SERVICE BULLETIN**SB25-03**

SUBJECT: Riveted V-Band Coupling, Part No. 670105
PURPOSE: Exhaust V-Band Coupling Rivet Inspection
COMPLIANCE: During 100-Hour/Annual Inspection or next engine/aircraft exhaust system maintenance event, whichever comes first
MODELS
AFFECTED: LTSIO-360-RB; TSIO-360-MB, RB, SB; TSIO-520-BE; TSIO-550-A, B, C, E, G, J, K, N; TSIOF-550-D, J & K engine models

Figure 1. Suspect Rivets Installed on Part No. 670105 Clamps

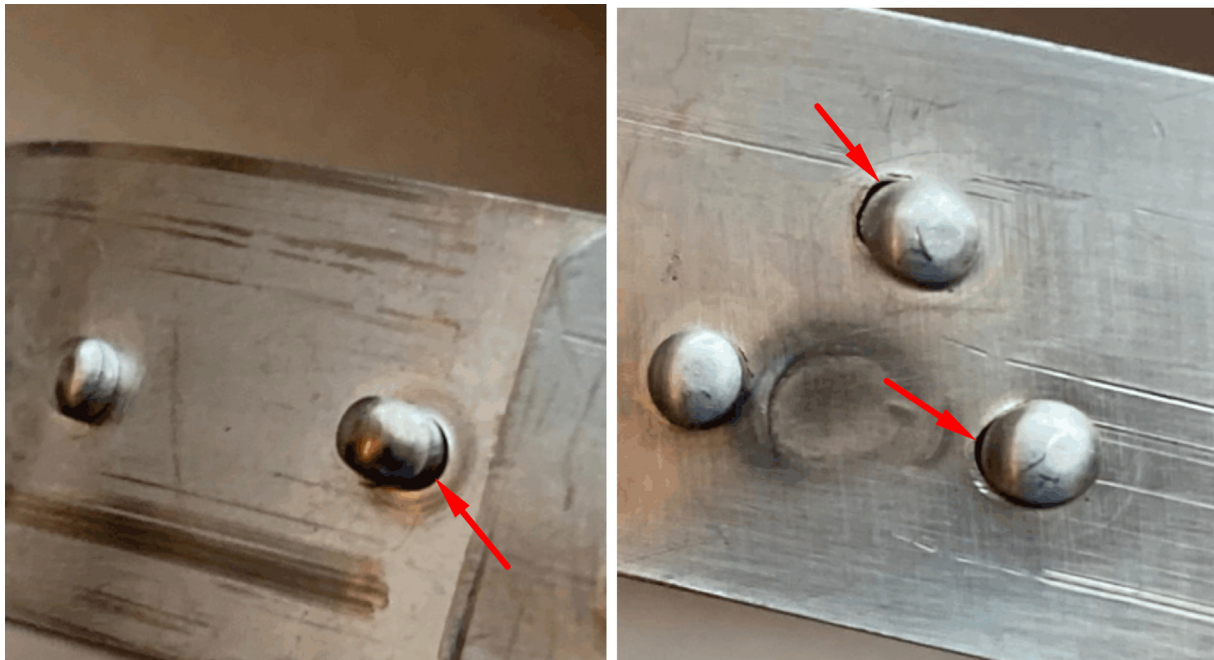
Continental has been notified some exhaust V-Band Coupling Part No. 670105 rivets may have been improperly formed during the manufacturing process. While the V-Band Couplings meet all functional requirements, the physical appearance of the rivets are not consistent with the industry standards for rivet installation (see amplified instructions in Section II.A). In Figure 1 below, the red arrows point to rivets that do not conform to industry standards.

Perform turbocharger and exhaust system inspection according to the instructions in M-0, Standard Practice Maintenance Manual, Section 6-4.21. While performing specified inspections, inspect the affected Part No. 670105 V-Band Coupling condition after removal. If the V-Band Coupling(s) exhibit any of the characteristics depicted in Figure 3, replace the suspect V-Band couplings according to the instructions in the applicable engine model primary ICA (see ICA Part No. to engine model cross-reference in M-0, Section 1-1.1).

Figure 2. Expected Rivet Appearance

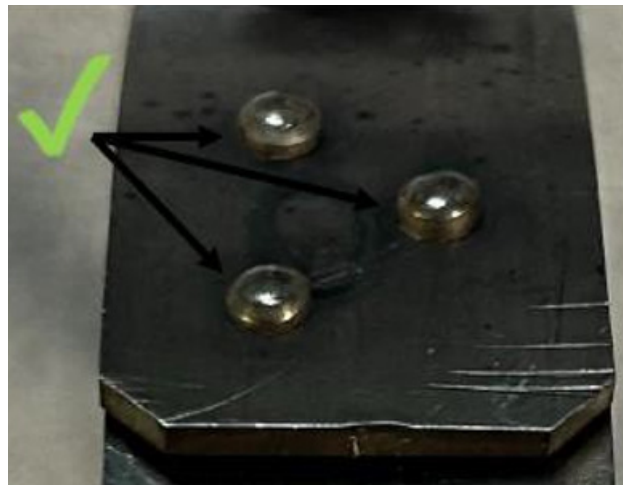
- Rivet Heads Exhibit a Distinct Mushroom Shape - Example A
- Rivet Conforms to the Shape Illustrated - Example A
- Rivet Head Shape is Consistent and Flush with Surface - Example A
- No Evident Material Damage Surrounding the Rivet Insertion Points - Example B

Figure 3. Suspect Rivet Appearance

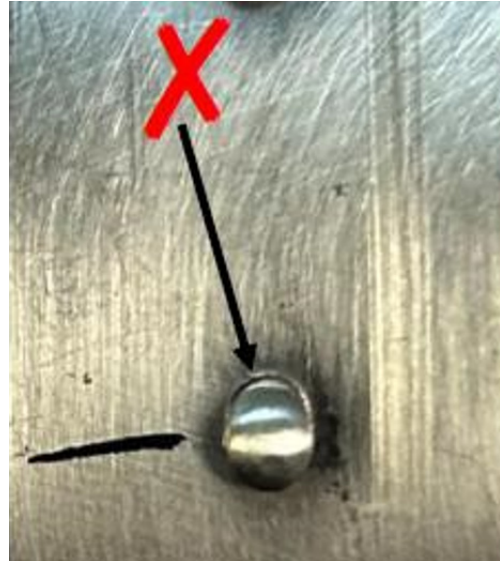
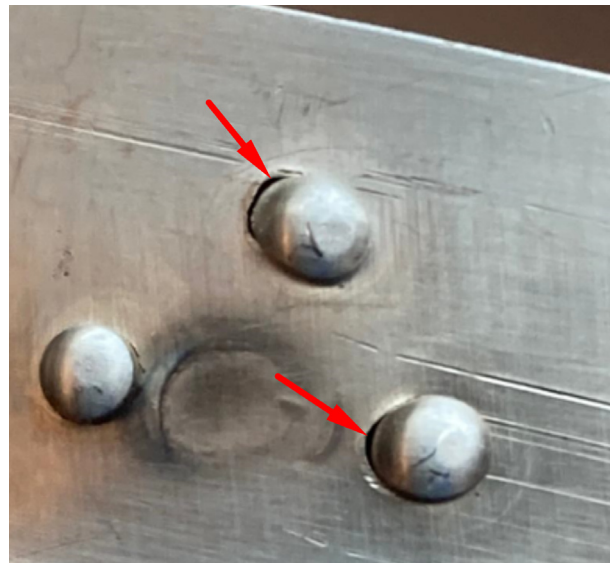
- Rivet Head Exhibits a Distorted Shape - Example C
- Rivet Head Shape is Inconsistent/Not Flush with Surface - Example D
- Evident Material Damage Surrounding the Rivet Insertion Points - Example E
- Visibility of Rivet Pre-Drill Hole - Example F
